Enclosed please find the comments of Catskill Mountainkeeper, Delaware Riverkeeper Network, Earthjustice, the Natural Resources Defense Council and Riverkeeper on the Revised Draft Supplemental Generic Environmental Impact Statement on the Oil, Gas and Solution Mining Regulatory Program, Well Permit Issuance for Horizontal Drilling and High-Volume Hydraulic Fracturing to Develop the Marcellus Shale and Other Low-Permeability Reservoirs, issued September 7, 2011, and draft regulations (Proposed Express Terms 6 NYCRR Parts 52, 190, 550-556, 560, 750.1, and 750.3), issued September 28, 2011.

RE: Technical Comments Summary Report: Expert Team Review of the 2011 Revised Draft SGEIS on the Oil, Gas and Solution Mining Regulatory Program and Proposed High-Volume Hydraulic Fracturing Regulations

Figure 1: Figure 2 from Fisher (2010) showing the well centerline and a depth to the top of the fracture zone.

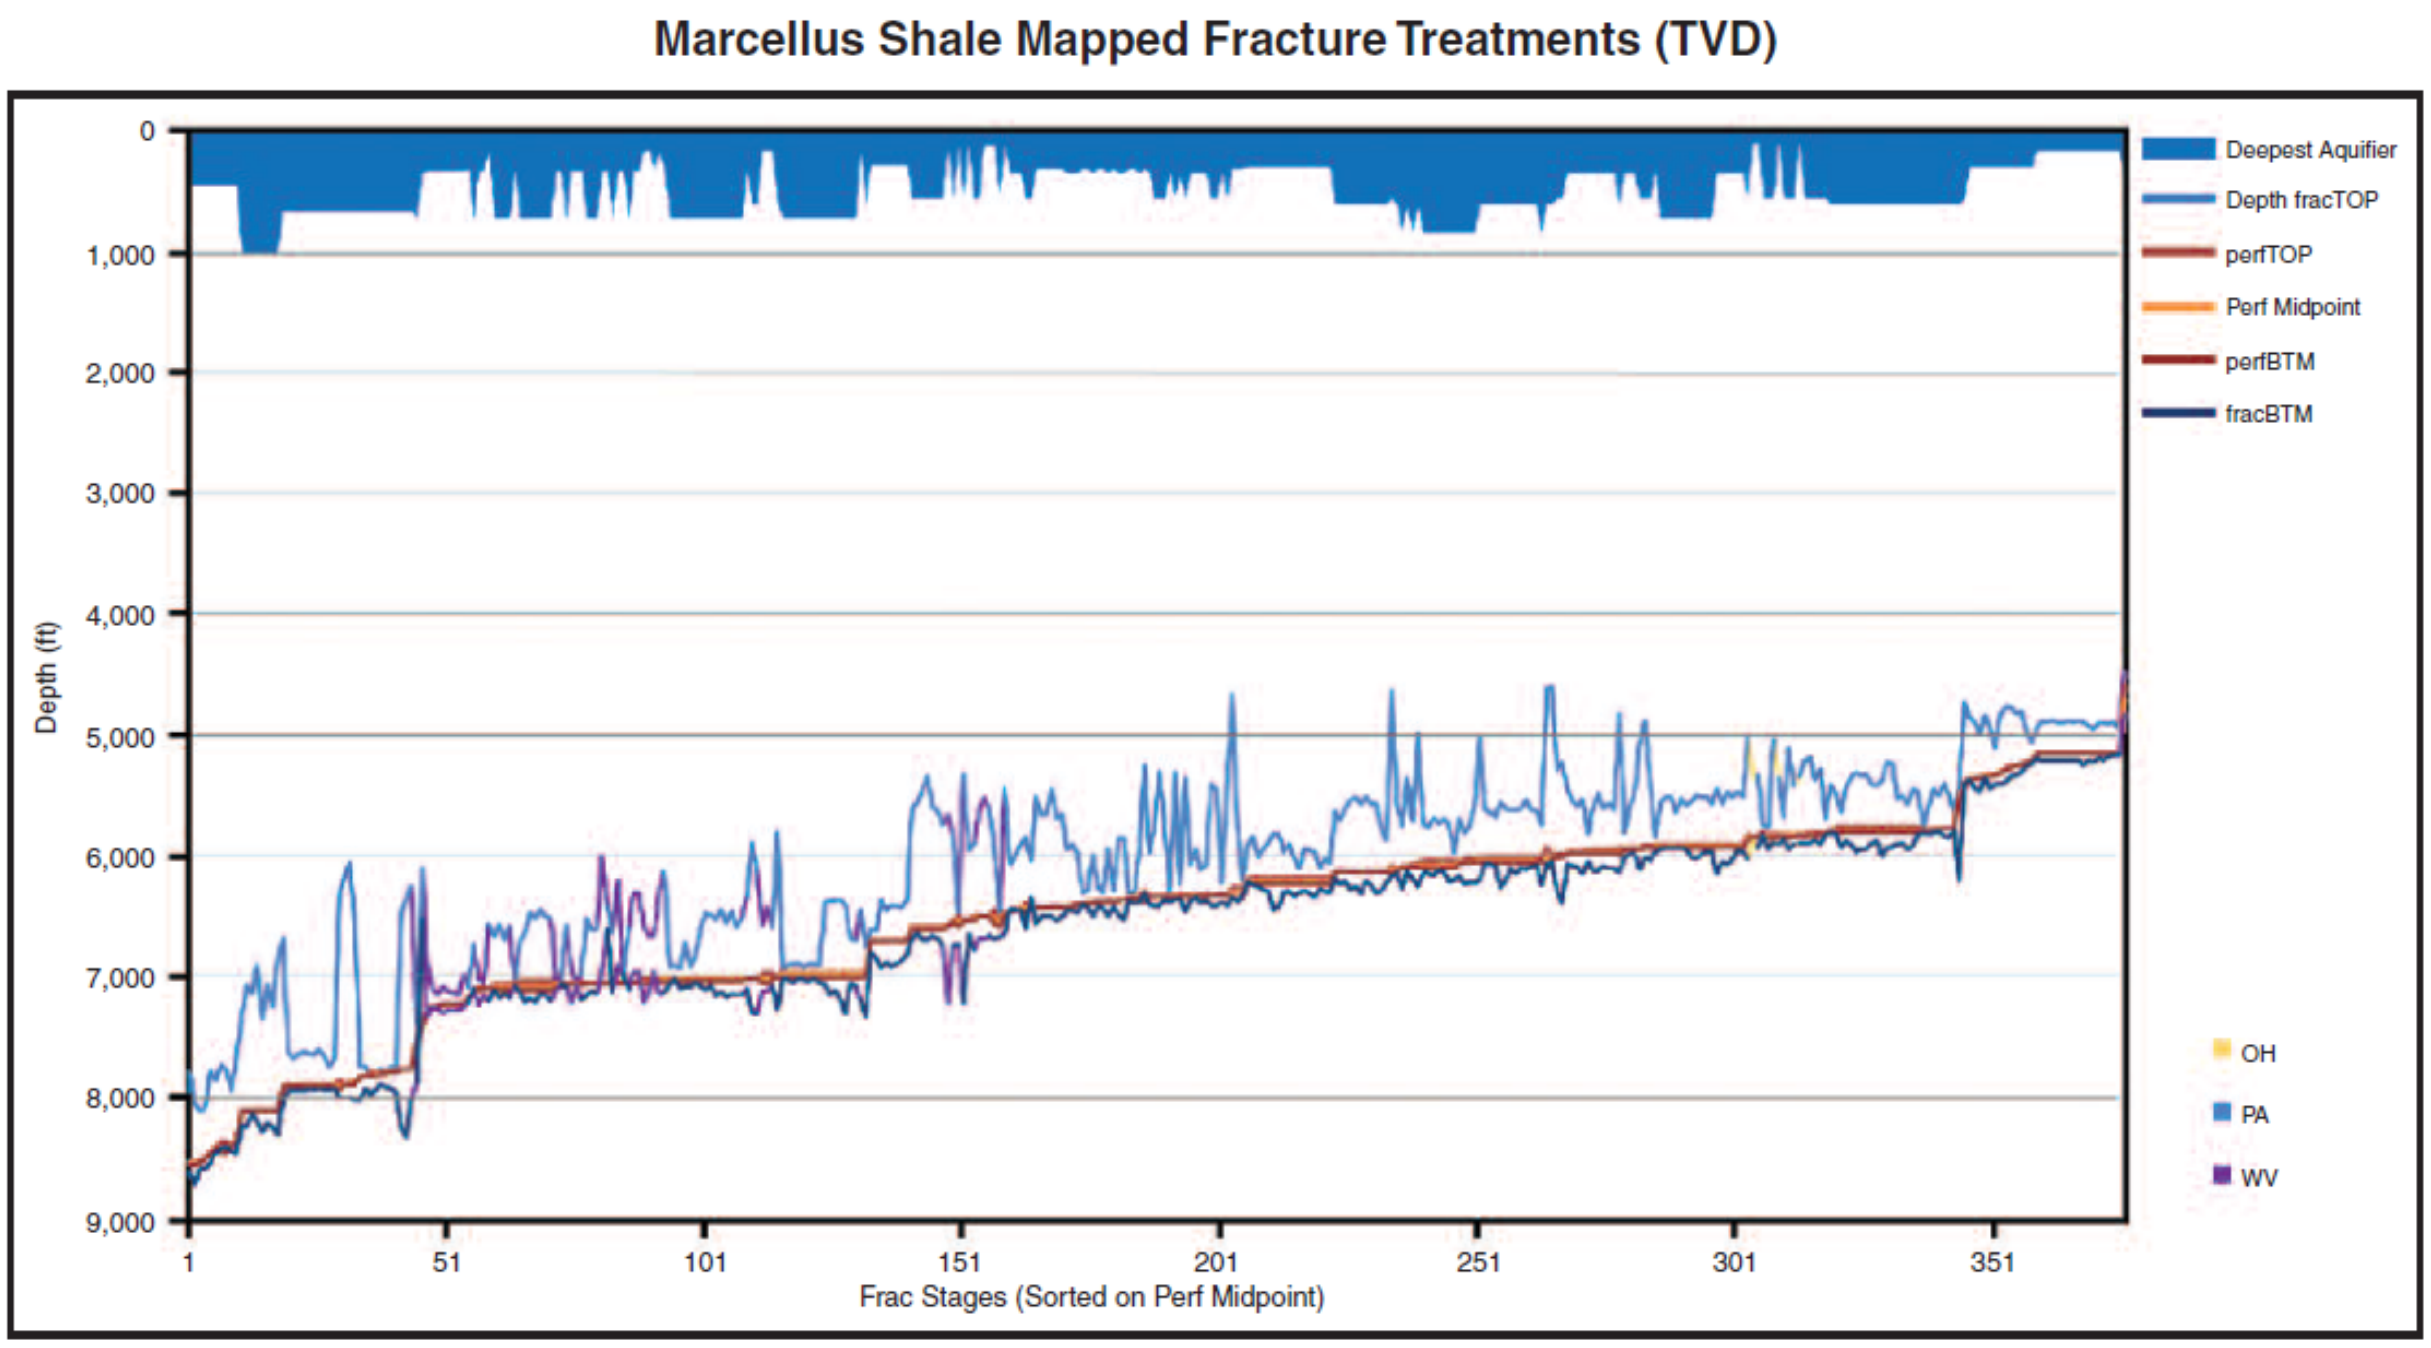
Industry designs fracking jobs to keep the fractures in the shale, but data show that the results of the fracking do not always or even often verify the design. The industry rarely monitors or measures the actual extent of fractures (RDSGEIS, p. 5-88), beyond monitoring pressure and injected fluid during fracking. The RDSGEIS references Fisher (2010) as being proof that fractures do not extend into the aquifer zone, but his data actually show that fractures commonly go out of formation (Figure 1). His data show many instances of the top of the fracture zone being more than 1000 feet above the centerline of the shale. As the depth to the centerline of the shale decreases from 8000 to 5000 feet, the vertical fracture growth also appears to decrease from 2000 feet above to 500 feet above the centerline of the shale. The apparent trend to fracture growth above the formation decreasing with decreasing depth may relate to the pressure on the rock or its hardness. The data were not sorted according to formation type and there is no data concerning shale thickness, therefore it is unknown whether fractures extend further in some types of rock or whether out-of-formation fractures are more common with thinner shales.

- *The RDSGEIS and regulations should require geophysical logging and microseismic tests to map how far fractures extend out of formation, and the density of the fractures in different formation. This information should be publically available so that all companies can benefit from experience and so that the public can better understand the process.*
